**Capacity Allocation Mechanisms (CAM) Network Code  
Stakeholder Engagement Document: Potential  
Modifications to the Network Code Following Receipt of  
ACER Opinion**

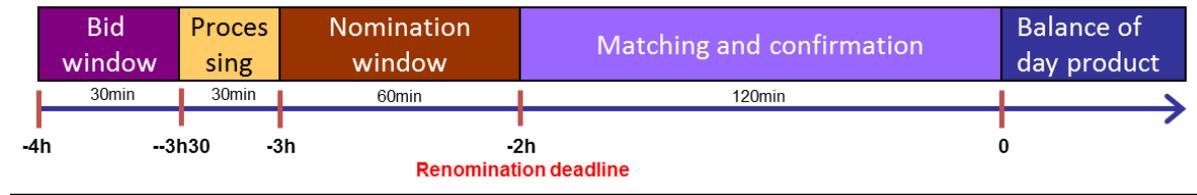
The CAM NC submitted to ACER specifies that there will be hourly auctions for firm within-day capacity (balance of day product), providing capacity is available. Under the current drafting, each bidding window opens 3 hours before the start of the capacity product and close 2 hours before.

An unintended consequence of this drafting is to restrict the usage of the capacity product, due to the length of the processes that must take place between the end of the auction and the start of gas flow.

As within-day auctions close 2 hours before gas flow and the necessary follow-up processes require at least 3 hours 30 minutes, this means that at least the first two hours of a within-day capacity product cannot be used (that is, two hours after the start of the product would be the first time by which the user could nominate against the capacity they have acquired and have their nominations confirmed). This may not be considered a satisfactory situation.

ENTSOG therefore proposes that each within-day bidding window should open 4 hours before the start of each capacity product and last for 30 minutes. This allows sufficient time for allocation, nomination, confirmation and matching processes to take place before the start of the capacity product.

The diagram below updates the information shown on page 17 of the ‘Explanatory Note for the CAM NC’ document published by ENTSOG on 30 January 2012<sup>12</sup>.

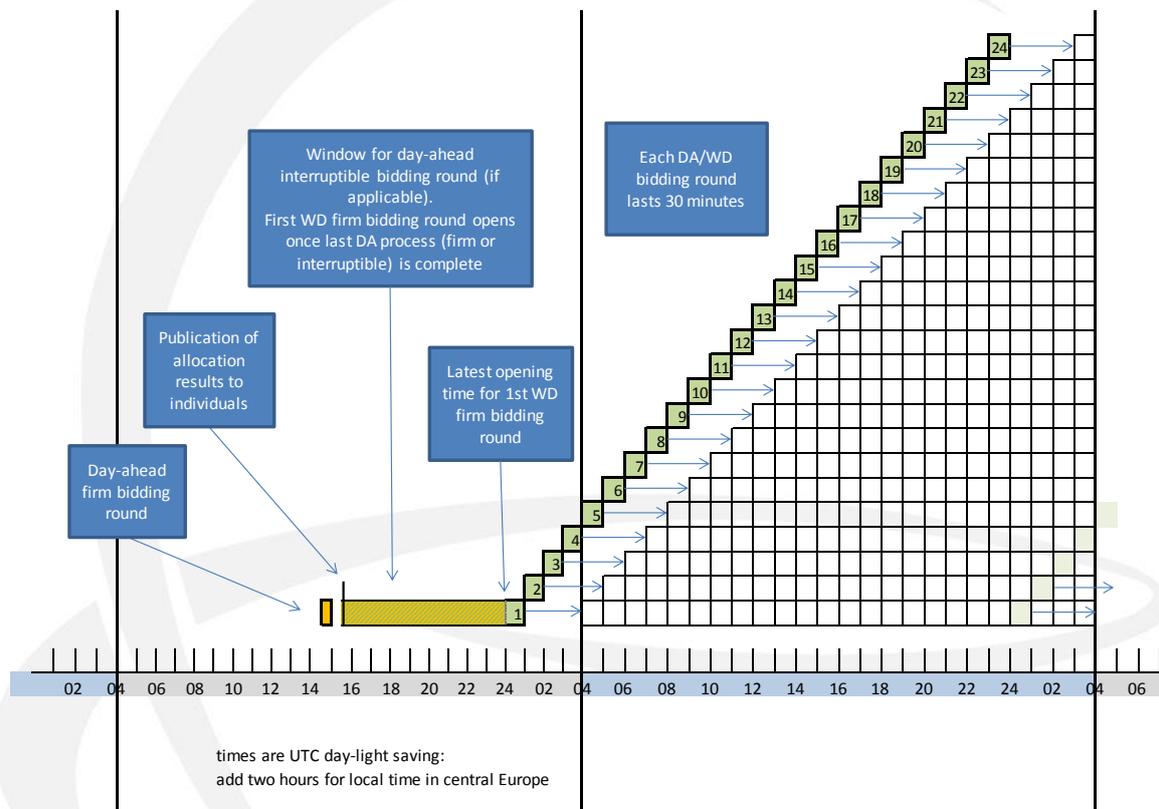
ENTSOG proposes one further change to the CAM NC: the first bidding round should open after the end of all day ahead allocation processes, including if applicable any auction for day ahead interruptible capacity. At the latest, the first bidding round will open 4 hours before the start of the gas day, but it will open earlier if possible.

CAM NC submitted to ACER	Proposal	Reasoning
<ul style="list-style-type: none"> <li>- 1<sup>st</sup> bidding round opens after publication of DA auction results</li> <li>- Each bidding round closes 2h before gas flow</li> <li>- 60 min bid window,</li> <li>- 15 min processing time</li> </ul>	<ul style="list-style-type: none"> <li>- 1<sup>st</sup> bidding round opens after end of interruptible DA allocation process</li> <li>- Each bidding round closes 3h30 before gas flow</li> <li>- 30 min bid window</li> <li>- 30 min processing time</li> </ul>	<ul style="list-style-type: none"> <li>- Avoid overlapping auctions and associated reduction in capacity offer</li> <li>- Consistent with TSO need for 30 min processing time and 2h confirmation/ matching time</li> <li>- Consistent with informal stakeholder views on time needed for WD bidding and nomination</li> </ul>

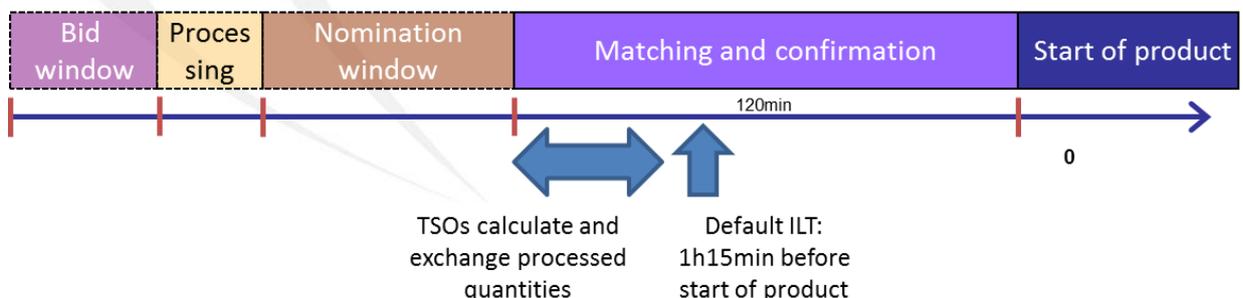
ENTSOG’s indicative view is that the CAM NC should be changed so that it refers not to an absolute number for the default lead time, but to a time period after the deadline for re-nominations. This

means that if the re-nomination deadline is shortened in future for any regime (to the benefit of users), the interruption lead time will automatically adjust in line with this.

*"The default minimum interruption lead time for a given gas hour shall be the closure of the re-nomination cycle for that gas hour minus 45 minutes to allow for processing and messaging. This means that if the re-nomination lead time is 2 hours, the interruption lead time is 1 hour and 15 minutes. If two TSOs wish to shorten the lead time for interruptions then any agreement on a shorter lead time will be subject to NRA approval."*

ENTSOG considers that it is necessary to allow 45 minutes after the re-nomination deadline for the processing of nominations and determination of whether interruptions may be necessary. As the Balancing NC is likely to provide for a two hour re-nomination lead time, this implies a default interruption lead time of 1 hour 15 minutes. Users receiving an interruption notice will therefore have a short window to re-nominate against their capacity before the next hour bar, if they wish to do so. They may also, or alternatively, choose to participate in the firm within-day auction starting on the next hour bar, in order to bid for capacity starting 4 hours later.

The diagram below shows a simple example. In this example, virtualisation between the two points is not possible for technical reasons.

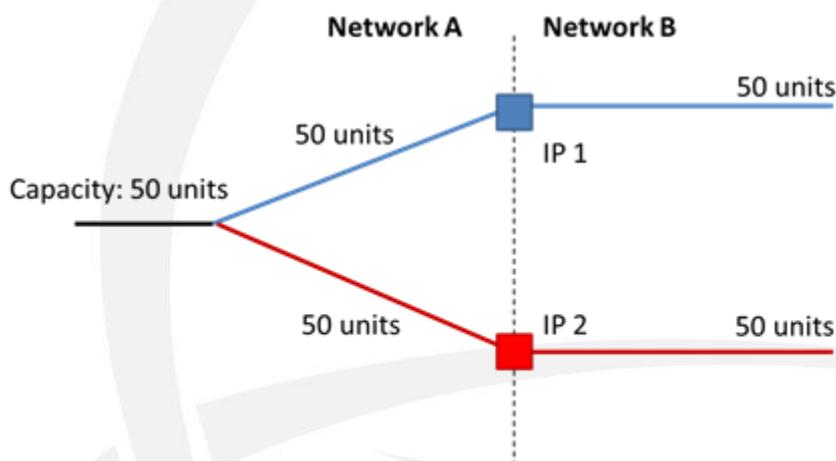
ENTSOG has identified an issue concerning the allocation of competing capacities, that is, capacity that can be allocated as either bundled product A or bundled product B, but not both. At present, such processes take place at a limited number of interconnection points across Europe, but early experiences of implementation suggest that this number may increase in future, particularly once the CAM NC requirements on bundling come into force.

A total of 50 units of cross-border capacity can be offered, either at IP1 (bundled product A), or at IP2 (bundled product B), or a mix of the two.

In such a case, it would not be possible for the auctions for product A and product B to be independent. At present, however, the CAM NC specifies that all auction processes must be independent of each other. ENTSOG understands that the allocation of competing capacities is considered by NRAs and users with experience of such processes to work well. It would not therefore wish for the CAM NC to prohibit Member States from implementing such competitive arrangements for the efficient usage of existing capacities.

ENTSOG's indicative view is therefore that Article 4.1 (2) of the CAM NC should be changed as follows (underlined text is new):

*"At all Interconnection Points the same auction design shall apply. The relevant auction processes shall be started simultaneously for all concerned Interconnection Points as far as reasonably possible. Each auction process, relating to a single Standard Capacity Product, shall allocate capacity independently of every other auction process, with the possible exception of auction processes allocating competitive capacity at two or more interconnection points."*
